Meeting Date: October 16, 2025 Item Number: 25-13	From: Mike Malyy, Caltrans
Sponsored By: Amjad Obeid, Caltrans	Presented By: Mike Malyy, Caltrans
Description: Request for review and recommendation to finalize CA MUTCD 2026 Part 9 titled "Traffic Control For Bicycle Facilities" proposed documents that have been revised in response to 10/2/25 CTCDC Meeting comments and is being prepared to adopt Federal Highway Administration's National MUTCD 2023 (11th Edition) before the January 18, 2026, deadline.

California Traffic Control Devices Committee Agenda Item Report

11. **CTCDC Comment – Chapter 9E, Section 9E.09, Paragraph 05, and Figure 9E-1:**

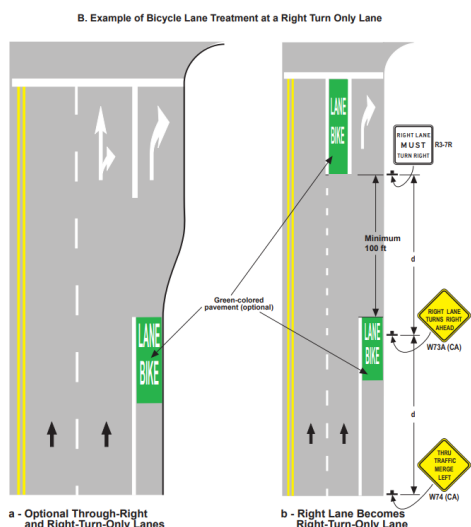
CTCDC member comment: I am concerned that many agencies will continue to use green under sharrows, helmeted bike rider stencil, and green plastic posts on bikeways, even though CAMUTCD now states that we are not allowed to use them. If Caltrans is a member of AASHTO and can work with 49 other states on this, this should provide adequate justification for FHWA.

FHWA comment: The experimental process in the national committee provides an outlet for these concerns to be brought forth and it has been done. The green bikeway under the sharrows has been extensively tested in experiments across the country. The policy and the manual now is the result of that experiment and research. There are 49 other states that do things differently and by law, has to be uniform. There hasn't been lack of discussion on this. The designer cannot vary. I cannot support a variance from the standards in the national manual. Our job is to ensure that the CA manual meets the code of the federal regulations. Caltrans staff has worked hard to do that, but it has not been without discussion and some good points have been raised by the subject matter experts. But the regulation is what it is, and the standard is what it is. The designer who chooses not to go with the standard has to make that choice, has to violate that consciously. Phasing out the helmeted bike symbol will take time. 20 years ago Caltrans agreed at that time that these things will be phased out with the next revision. The next revisions came and went and here we are 20 years later and it is time to conform with the CFR. Unfortunately, there is going to be disagreements and there are thousands of examples in the state on one type of device that are non-compliant. Caltrans has made that conscious choice over and over again to not comply with the manual. That does not make it right. We cannot support deviations from the standards and guidance unless it complies with the CFR. Caltrans can pass a law which make it more restrictive but they cannot pass a law to make it less restrictive than the MUTCD. So, 1) We do not a lot of leeway and 2) Caltrans doesn't have a lot of time on this manual update.

Caltrans acknowledged the comment and explained that FHWA produced the new standard, and justification is needed to deviate from Federal standard.

Figure 9E-4(CA). Example of Bicycle Lane Markings on an Approach to an Intersection that Transitions from a Shared Lane

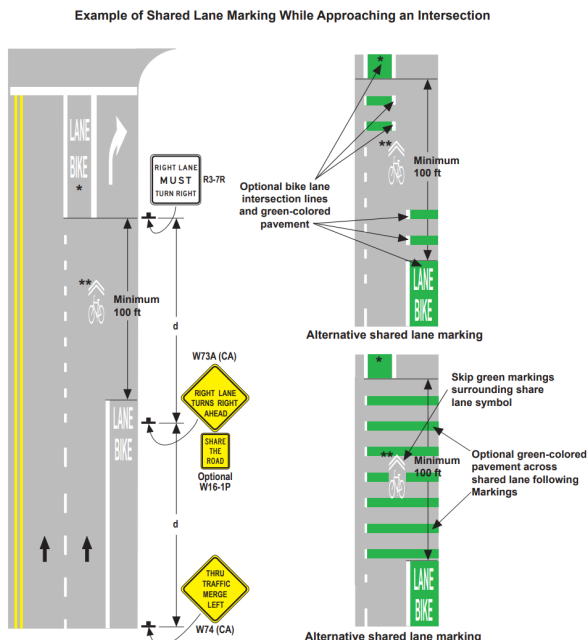
CTCDC member comment: The title is incorrect. Should be: Example of Bicycle Lane Markings on an Approach to an Intersection where the Right Lane Becomes a Right Turn Only Lane.

Also, because it is not directly related to national MUTCD Figure 9E-4, it seems like it should be part of the Figure 9E-3 series.

Caltrans comment: 9E-4(CA) is similar to 9E-3(CA) (Sheet 2) drawing b, but is more focused on the shared lane markings and adds additional details regarding that. Will change 9E-4(CA) to 9E-3(CA) (Sheet 3), and shift the following sheets.

Figure 9E-8(CA). Example of Counter-Flow Bicycle Lanes (Sheet 2 of 2)

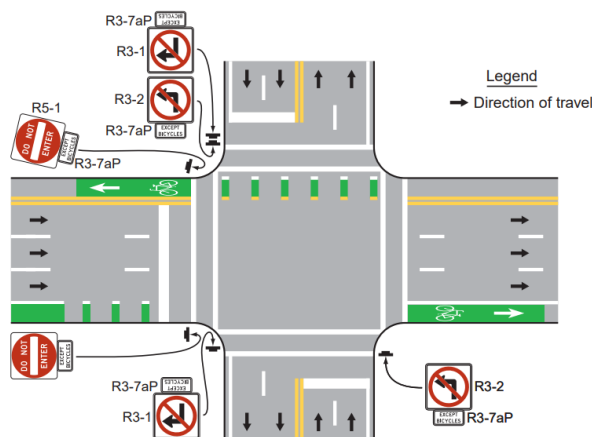
CTCDC member comment: This figure is nearly identical to Figure 9E-8 (the only substantive difference is green paint in the counter-flow bike lane approaching the intersection). Should Figure 9E-8(CA) (Alternatives 1 and 2) replace Figure 9E-8 rather than supplementing it?

Caltrans comment: Whenever we make several changes to a Federal Figure, we create a new supplemental figure(s). We feel there are enough changes to have a new figures.

16. CTCDC Comment – Figure 9E-106(CA):

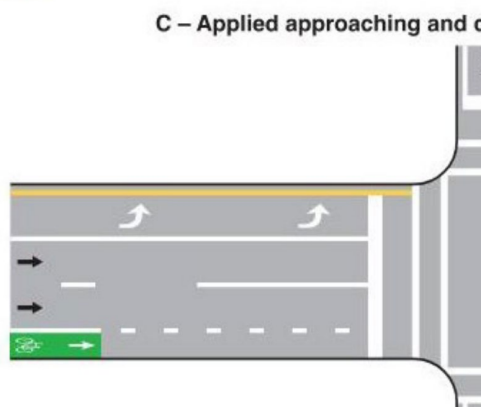
CTCDC member comment: How do these work with Figure 9E-7 Examples of Markings for Separated Bike Lanes (Sheets 1 and 2)? They seem to very closely cover the same material, and if there is no distinction between Separated Bike Lanes and Separated Bikeways, then why two sets of very similar details?

Both bikeways (CA figures) and bicycle lanes (federal figures) are being used in this case as general terms for dedicated bicycle facilities. CA Figures exist to provide more examples. Can evaluate for redundancy in the future.

Also, the Figure on Page 40 should be titled Figure 9E-105(CA).
